The City of Spartanburg Board of Architectural Design & Historic Review

AGENDA

April 11, 2024, at 5:30 P.M.

RE: RE: COA: 24-004-00017: Certificate of Appropriateness for Major Works – 481 S. Irwin Avenue (TMS: 7-16-02-137.00) in the Hampton Heights Neighborhood Historic District. The applicant is seeking approval to remove existing and replicate original pickets and railings on the front porch. The property is located in the R-8 SFD (General Residential – Single-Family District) zoning district. Owner/Applicant: John Edwin Foster, Paula Foster Paul / Contractor: Nicklas Renfro.

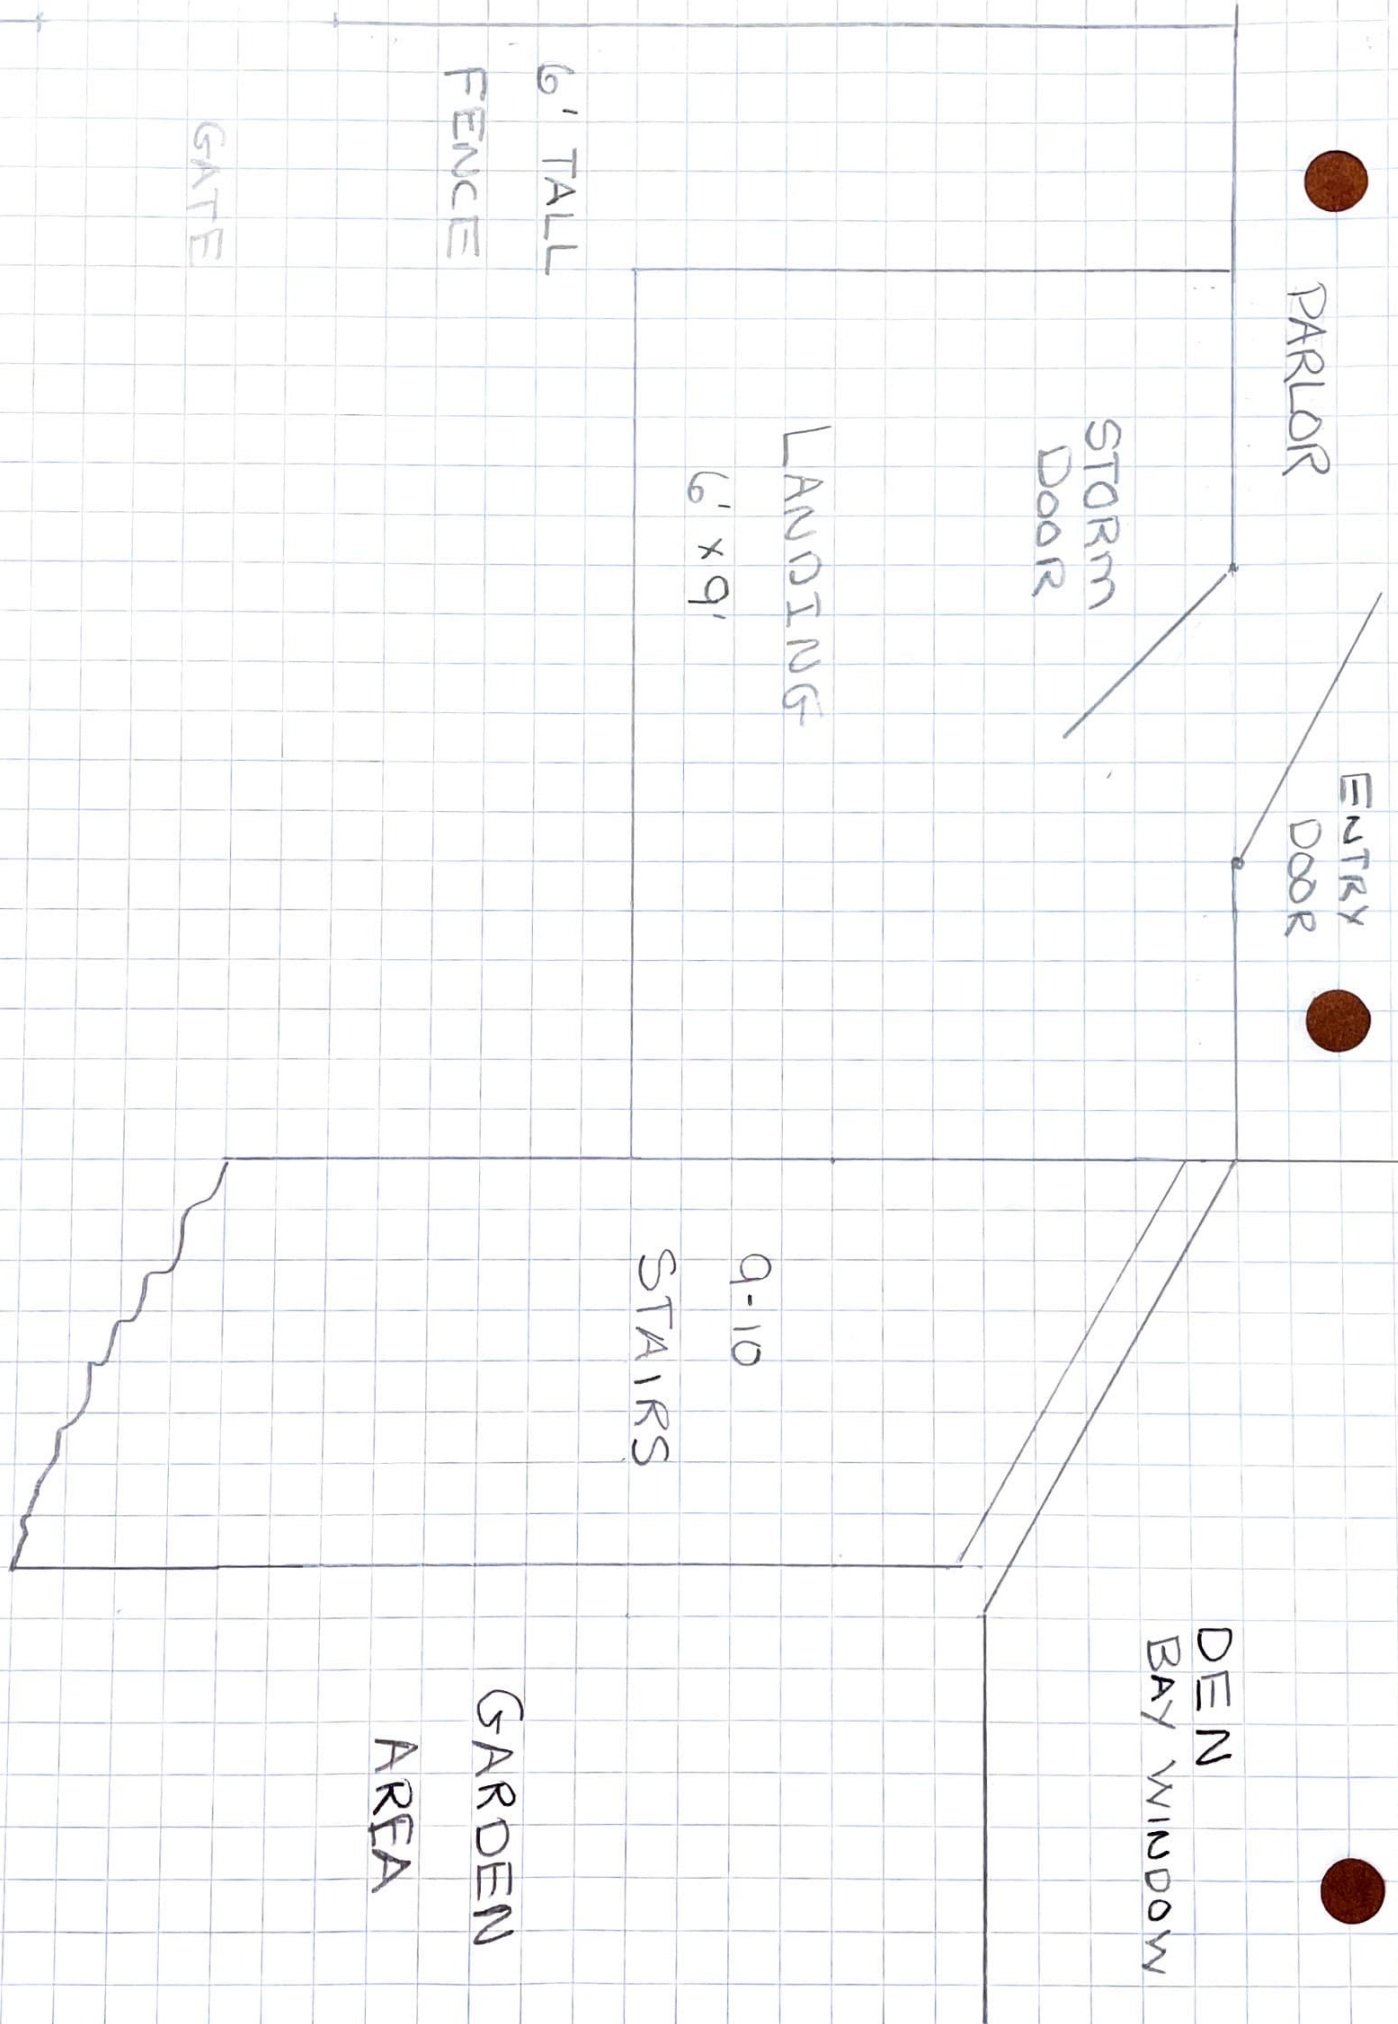
We propose removing the deck and stairs, now not visible behind a six foot high fence, replace it with a smaller landing area the same height as the front porch. The landing will have a balustrade the same as the front porch, allowing for the restoration of some architectural details. See attached an outline plan of the landing/stairs.

Steps would lead down to the garden and would follow the shape of the existing bay window at that part of the house. The area beneath the landing would be enclosed with a checker board lattice. See photo #10
